ADDENDUM NO. 1

**IPSWICH**  
**Bridge Replacement Br. No. I-01-007 (Steel)**  
**Route 1A (High Street) over the MBTA & B&M Railroads**

Transmitting revisions to the Contract Documents as follows:

PART OF SHEET NO. 8 of 46 Revised

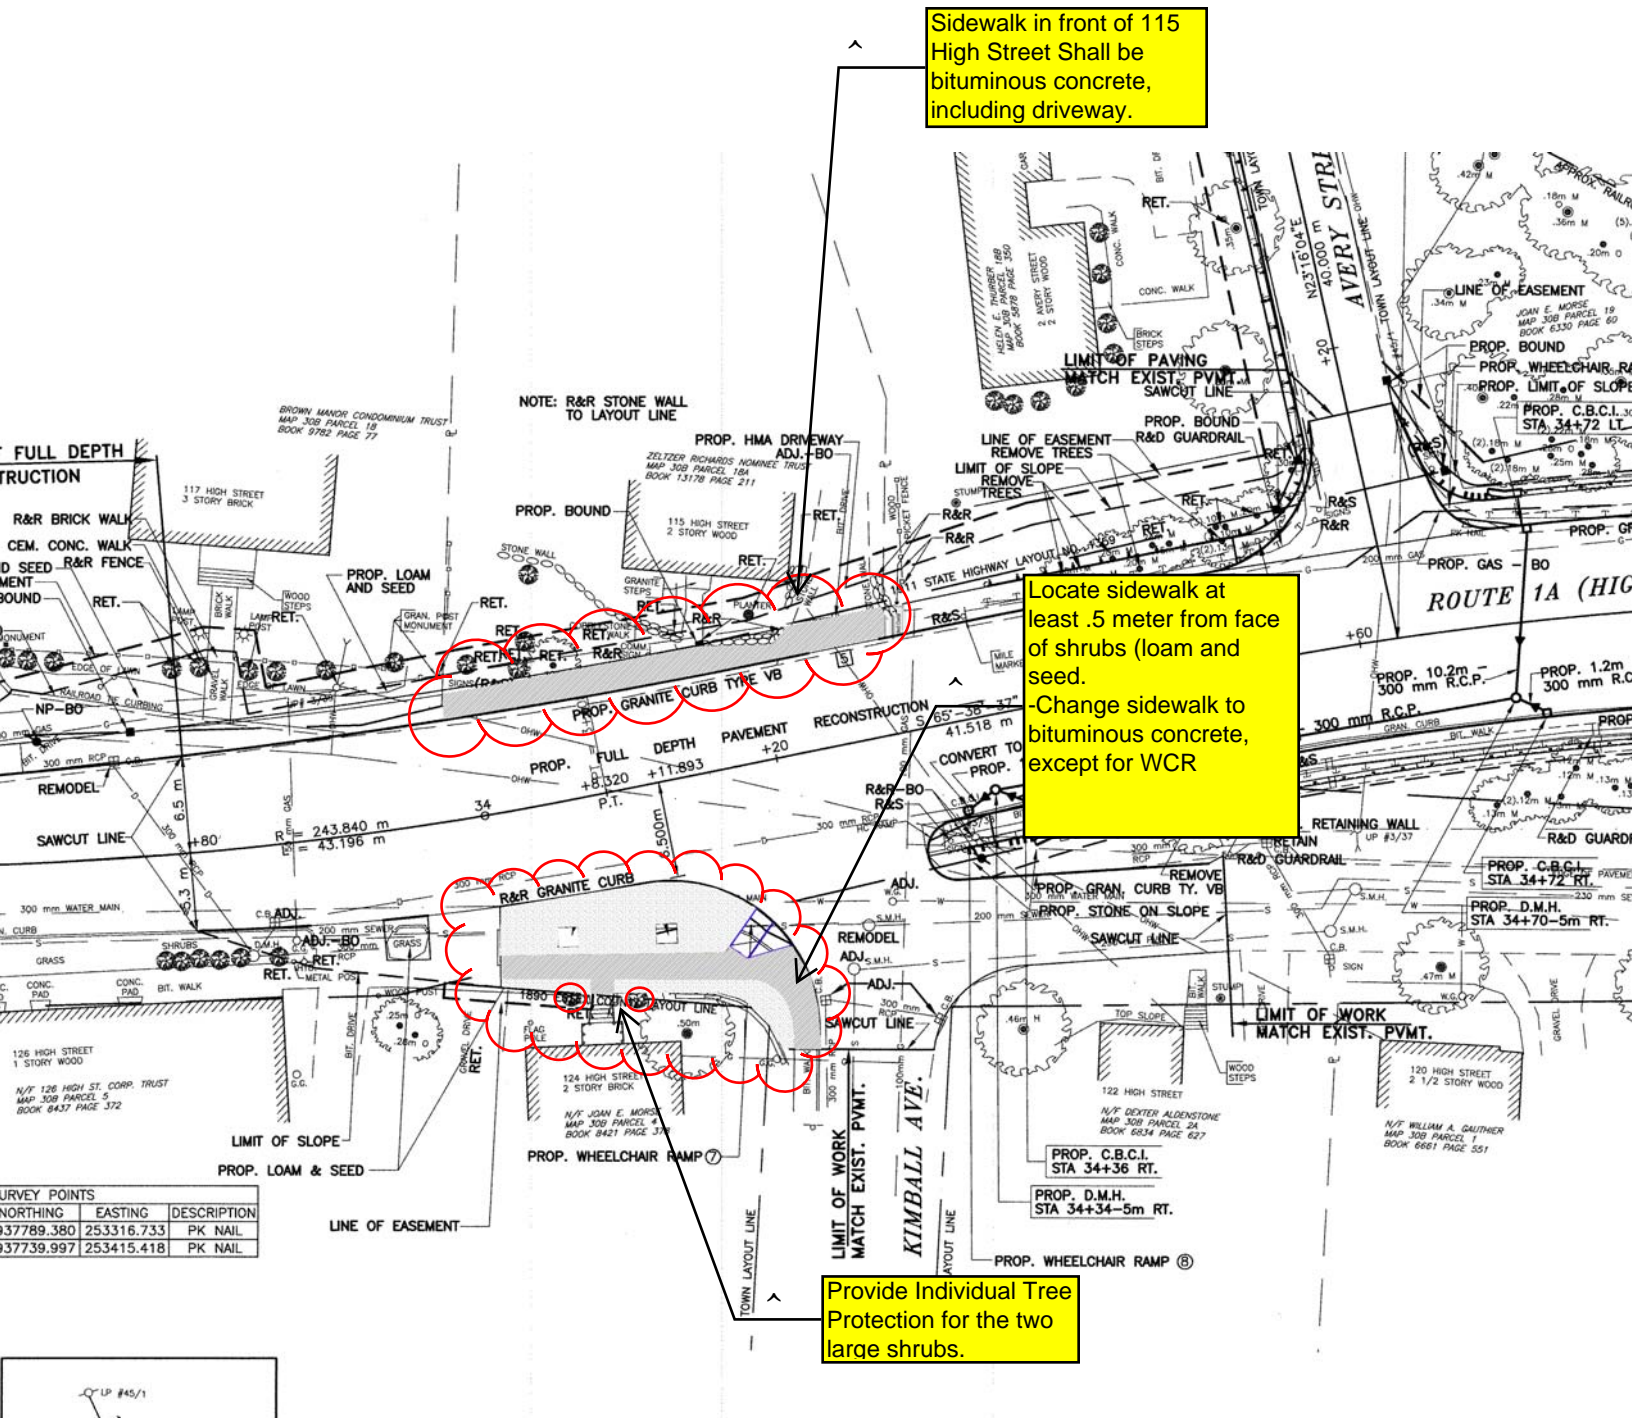
**PART OF SHEET NO. 8 of 46 revised.**

The whole Sheet No. 8 of 46 showing these revisions will be issued later.
